Queries from Campbell Reith 14/09/2016

**Figure 1: Relative position of New End Theatre to proposed development. Offset approximately 6.8m.**

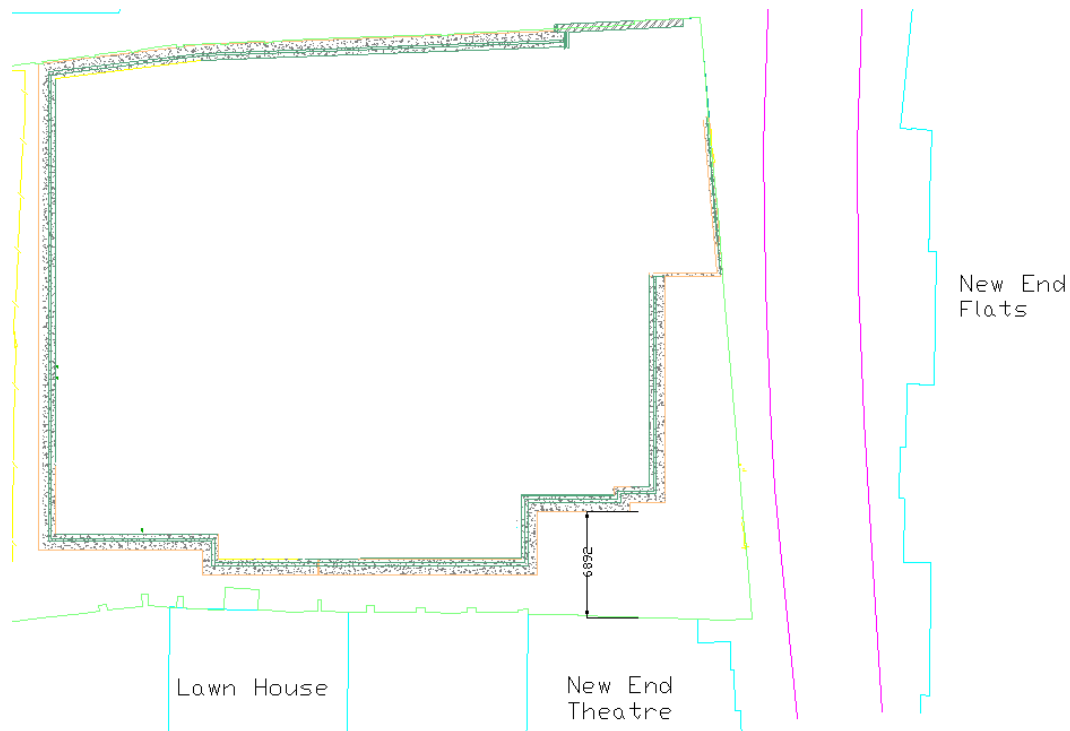
Our query with respect to the length of the elements was in relation to wall lengths and heights. We had the impression that width and height of the New End Theatre are less than assumed in your modelling (i.e. is it appropriate to take 7.9m when it is a single storey structure with a pitched roof?). It would also appear from KSR drawing NEN - PL - 003 that the theatre is only 2 -3 m from the proposed basement.

Although some wall heights of New End Theatre are smaller in reality than assumed, the adopted wall height of 7.9m used in the analyses should provide more conservative estimates of the building damage category for this structure.

Referring to Figure 1 below, the relative location of New End Theatre to the proposed basement retaining wall can be seen explicitly. The basement retaining wall outline can be seen to divert away from New End Theatre. The relative setting out of the excavation and the surrounding buildings used for the Xdisp analyses is based on the available survey information as presented. It is our belief that building damage assessment captures this geometry accurately.

Figure 2: Delineation of Sand and sandy silty Clay of Bagshot Formation (modified from GIR report in BIA).

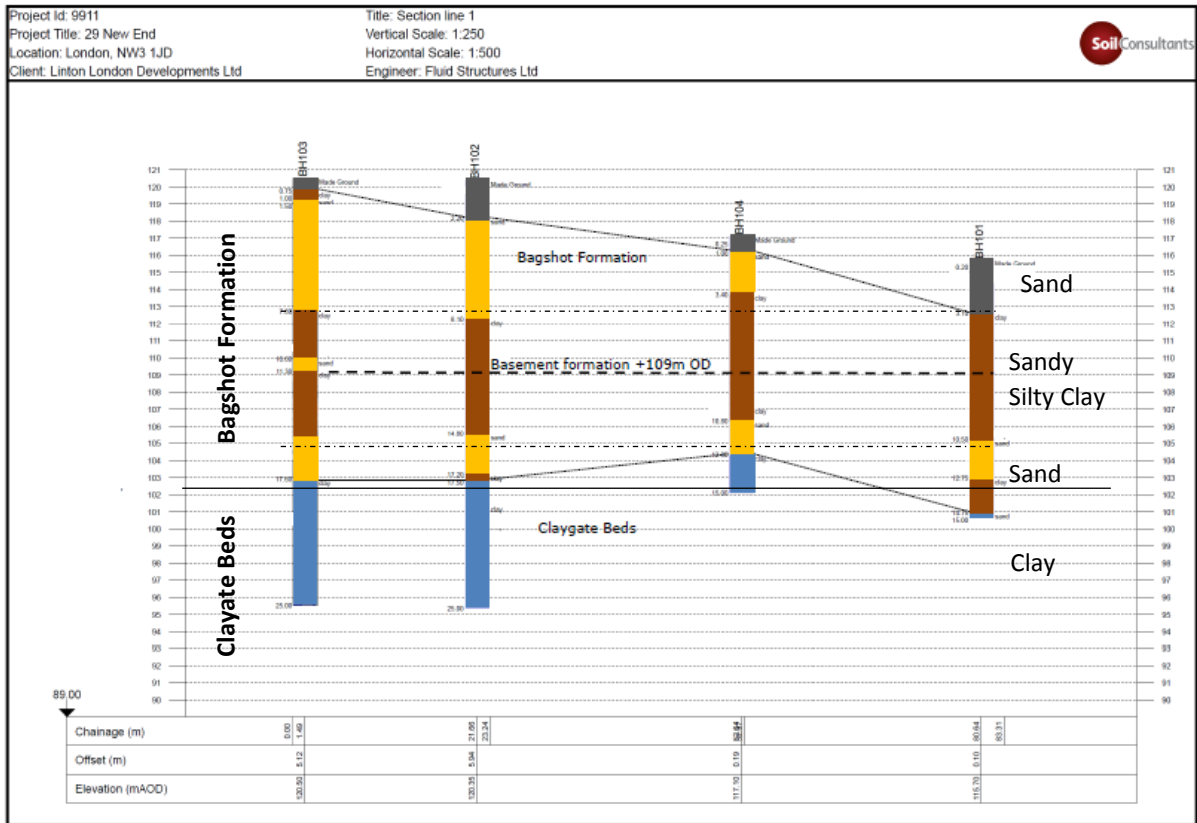
You refer to cohesive soils below 102m OD. The factual information supplied by SCL shows a significant cohesive layer below 112m OD. Can you please clarify the ground model (that presented in Tables 2.1 and 2.2 does not give elevations and Fig 2.3 is difficult to interpret). Is there a possible explanation for the 'outlier' in the data exhibited by BH101? It is difficult to ignore it if it cannot be explained.

The clay layer referred to is a part of the Bagshot Formation, which was typically described as a sandy/silty Clays and identified between approximately +113m AOD to +105m AOD in the site investigation report. Figure 2 reproduced from the recent GIR illustrates the assumed stratigraphic profile through the site.

This layer was incorporated into the FE modelling, between the elevations described previously. For modelling purposes it was considered to be conservative to model this layer as drained, as there may be numerous drainage paths from interconnected sand lenses within the deposit, which may enable relatively fast dissipation of excess pore pressures. The effective stress parameters were estimated based on the plasticity index of the clay, as shown in the GMA. This is considered to be conservative as the shear strength of the soil based on effective stress parameters would be typically less than the strength of the soil if a short-term undrained strength was adopted (based on say  $s_u = 5N_{60}$ ). Thus, in the FE modelling, larger ground strains would be induced.

Figure 4: Preliminary arrangement of temporary sheet pile and propping to enable secant pile wall construction.

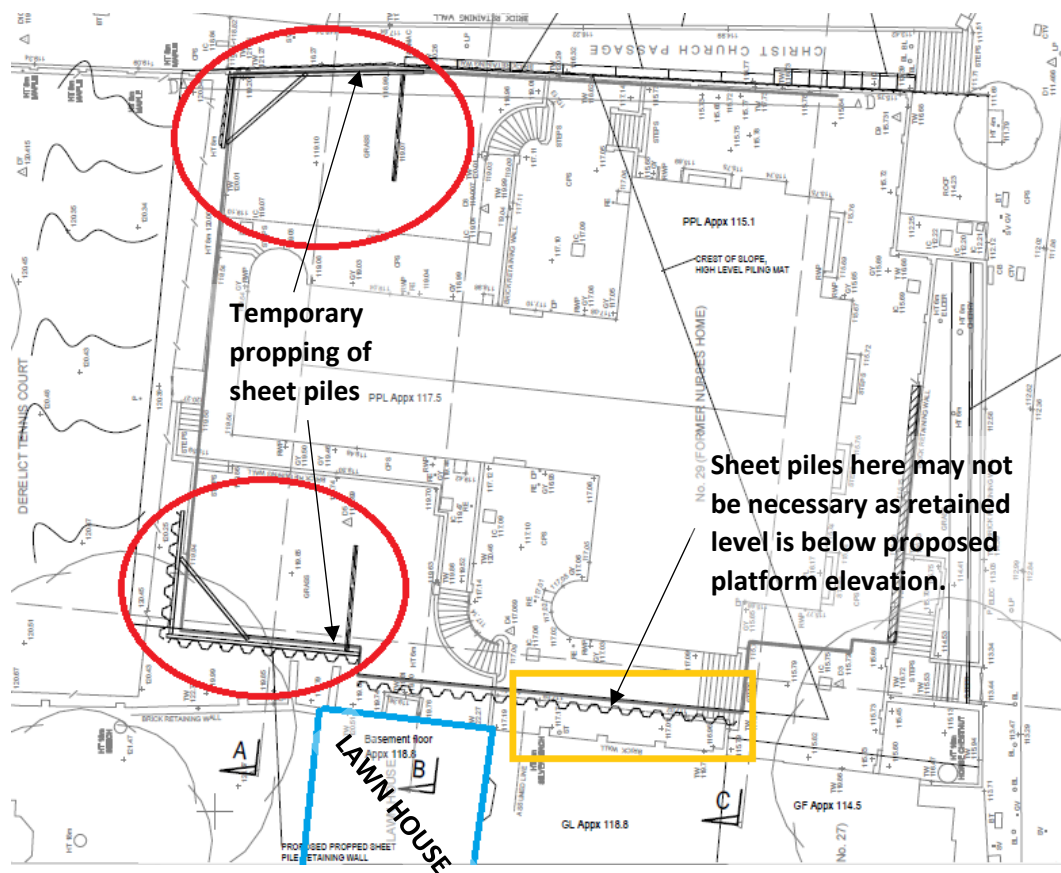
I am confused as to whether walls are propped or are to act as cantilevers, and have some other queries.

- During construction, the temporary sheet pile walls required to enable secant pile wall installation are shown as having some temporary propping provided. Refer highlights in Figure 4.
- During construction, the secant pile walls are propped from a high level with large diameter CHS Sections. Refer highlights in Figure 5.
- In the permanent case, the walls are partially propped by the permanent basement/floor slabs with the top portion of the wall cantilevering in some locations. Drawing sections BIA/006-1 to BIA/006-5 (Appendix E of BIA) best illustrate the typical wall restraint following the end of construction.

**Figure 6: Horizontal ground deformation with sheet pile wall cantilevered in temporary case.**

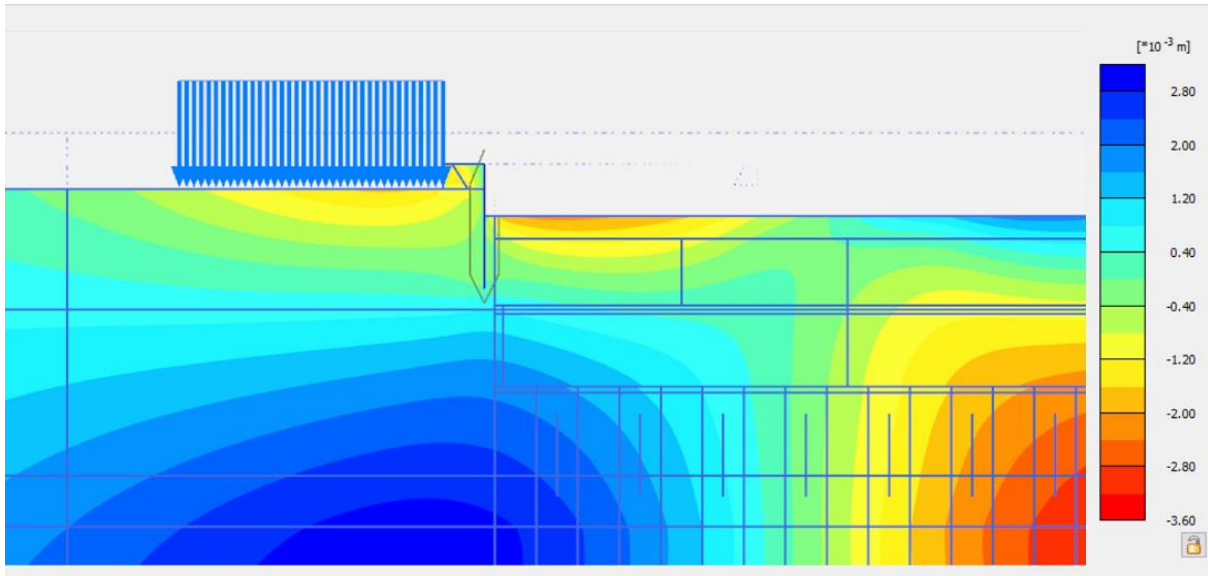
Item 5 - paras 1 & 2 - you note that the sheet pile walls have been considered in the FEA and then state that 'it is expected that the proposed temporary retention ..... will not lead to excessive ground deformations'. Is that confirmed by the FEA?

We have assessed two scenarios, which incorporate sheet piles without a temporary prop and sheet piles with a temporary prop. The horizontal ground movements at the sheet pile wall are estimated to be less than 5mm in both cases. Output from both cases is provided in Figure 6 and Figure 7.

Figure 8: (a) Actual excavation geometry (b) Simplified excavation geometry

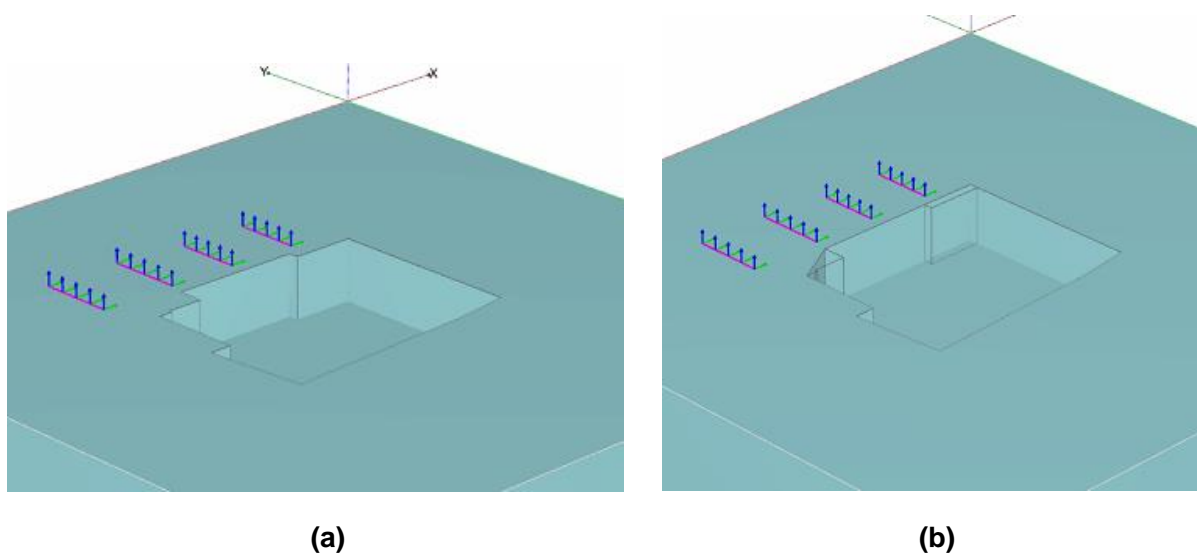
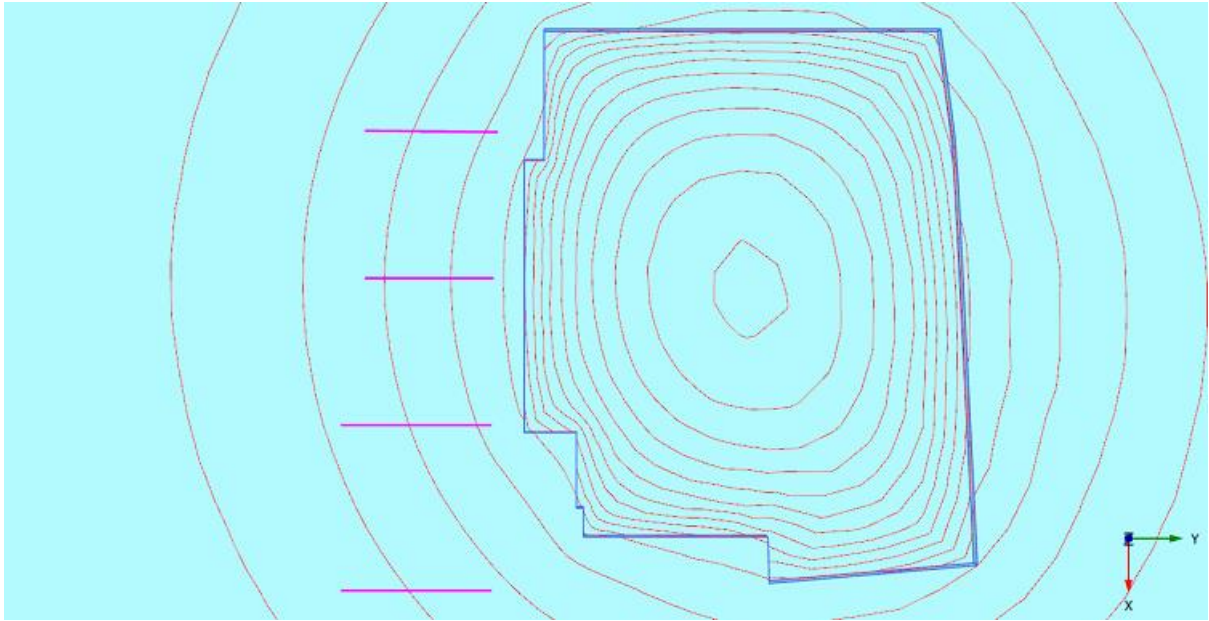
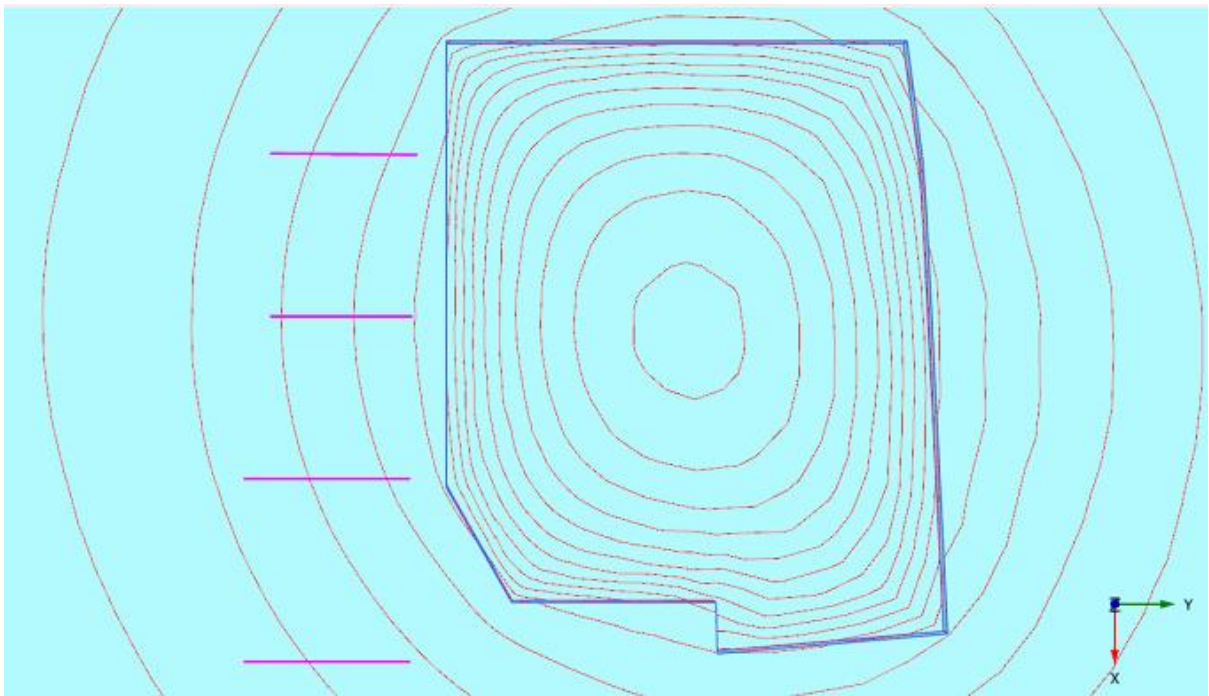
Item 6 - para 4 - whilst we concur that 2D analyses tend to overestimate ground movements, your modelling at the moment does not allow for the re-entrant corners in the SW and NW. How might this affect the damage predictions?

There is no consistent means by which the effect of re-entrant corners can be handled with simplified models such as Xdisp. The approach taken for the New End basement analysis was to simplify the excavation geometry and remove the re-entrant corners by offsetting the excavation perimeter as shown in Figure 8. The removal of the re-entrant corners by the adopted method, was assessed to be conservative because the process effectively decreased the distance between the nearest retaining wall and neighbouring structure.
